Access Compliance Report

Public Rights-of-Way

Intersection ID: 15174	Main Street: DILWORTH_RD_WEST	Cross Street: IDEAL_WY	Location: NE
ADA ID: D2F3F84E40D5	Ramp Type: Perp	Initial Pass/Fail: Fail	Overall Compliance: No
			Severity Score: 13.75

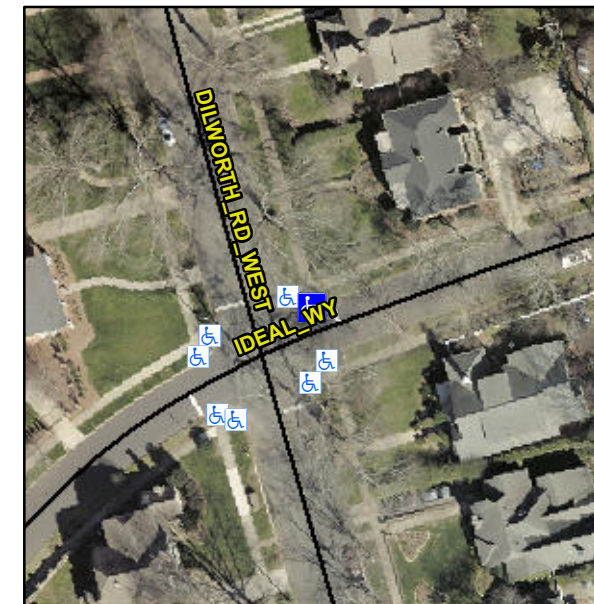
Not Found, R304.2.2, R304.5.3

Compliance	Description	Data	Compliance	Description	Data
N/A	Ramp Length (in)	79.0	No	Ramp Slope (%)	8.4
Yes	Ramp Width (in)	48.0	No	Ramp XSlope (%)	2.7
N/A	Flare Type LT	N/A	N/A	Flare Type RT	N/A
N/A	Flare Slope LT (%)	N/A	N/A	Flare Slope RT (%)	N/A
N/A	Flare Traversable LT?	N/A	N/A	Flare Traversable RT?	N/A
N/A	Landing Length (in)	N/A	N/A	DWS Provided?	N/A
N/A	Landing Width (in)	N/A	N/A	DWS Contrast?	N/A
N/A	Landing Slope (%)	N/A	N/A	DWS Length (in)	N/A
N/A	Landing X Slope (%)	N/A	N/A	DWS Full Width?	N/A
N/A	Landing Curb? (Y/N)	N/A	N/A	DWS Offset (in)	N/A
N/A	Shared Landing?	N/A			
N/A	Gutter Ponding?	N/A	N/A	Gutter Slope (%)	N/A
N/A	Gutter Lip Ht (in)	N/A	N/A	Gutter X Slope (%)	N/A
N/A	Painted X Walk1?	No	N/A	Painted X Walk2?	N/A
	X Walk 1 Direction	To S		X Walk 2 Direction	N/A
N/A	X Walk 1 Width (in)	N/A	N/A	X Walk 2 Width (in)	N/A
	X Walk 1 Slope (%)	2.4		X Walk 2 Slope (%)	N/A
	X Walk 1 X Slope (%)	0.8		X Walk 2 X Slope (%)	N/A

Remove & Replace Entire Ramp.
